**Docket Item #10**  
**Development Special Use Permit #2017-0015**  
**Coordinated Development District Concept Plan #2017-0002**  
**Special Use Permit #2017-0092, Encroachment #2017-0003**  
**Transportation Management Plan SUP #2017-0097**  
**200 Stovall Street - Hoffman Town Center Block 6A**

<b>Applicant</b>	<b>General Data</b>	
<b>Project Name:</b> Hoffman Town Center, Block 6A  <b>Location:</b> 200 Stovall Street  <b>Applicant:</b> Perseus Realty, LLC	PC Hearing:	September 7, 2017
	CC Hearing:	September 16, 2017
	If approved, DSUP Expiration:	N/A*
	Plan Acreage:	1.5 acres (65,161 sq. ft.)
	Zone:	CDD #2
	Proposed Use:	Residential and Retail
	Gross Floor Area:	Residential: 594,108 sf Retail: 36,475 sf
	Small Area Plan:	Eisenhower East
	Green Building:	LEED Certified for residential; requesting flexibility for retail

**Development Special Use Permit #2017-0015**  
**Coordinated Development District Concept Plan #2017-0002**  
**Encroachment #2017-0003**  
**Special Use Permit #2017-0092**  
**Transportation Management Plan SUP #2017-0097**  
**200 Stovall Street**

237. Show fire apparatus vehicle turning radius based on the following specifications:  
Tower 203 Turning Specifications

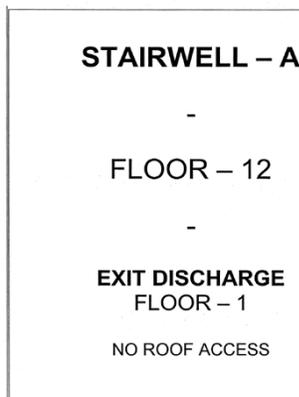
- Turning Radius – Wall to Wall = 54.98 feet + / - 2 feet  
Curb to Curb = 51.33 feet + / - 2 feet  
Inside turning radius = 37.73 feet + / - 2 feet
  - Overall Length – 47' – 4 1/2"
  - Overall Width – 98"
  - Wheel Bases from front axle to both rear axles – 240"
  - Tandem axle spacing – 56" CL of axle to CL of axle
  - Gross Weight – As built with no equipment or water gross weight = 66,000#
  - Angle of Approach – 13 Degrees
  - Angle of Departure – 11 degrees
  - Ramp Break Over – Break over angle is 9°

Example Stairway Identification Sign

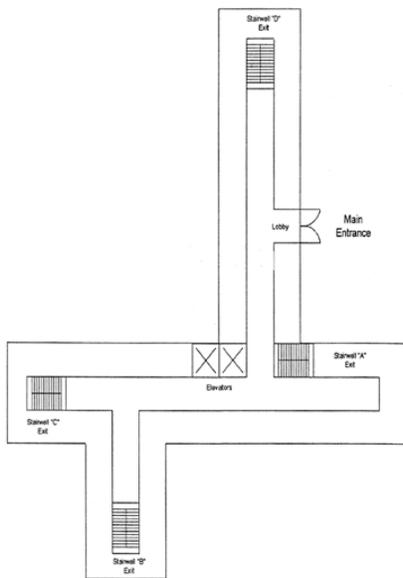
238. Provide Stairway Identification. Stairway identification signs shall be provided at each landing in all interior exit stairways connecting more than three stories. Stairways shall be identified by letter designation starting next to the main entrance with "A" and continuing in a clockwise or left to right pattern using consecutive letters of the alphabet for each additional stairway. Two copies of the stairway signs shall be submitted to the fire official for approval before occupancy.

In buildings greater than three stories where there is no graphic representation of the building footprint, a simplified building schematic must be display in the lobby. The simplified building footprint shall be an overhead view of the building exterior and the general layout of the lobby of the first floor. Stairways shall be denoted by letter as required
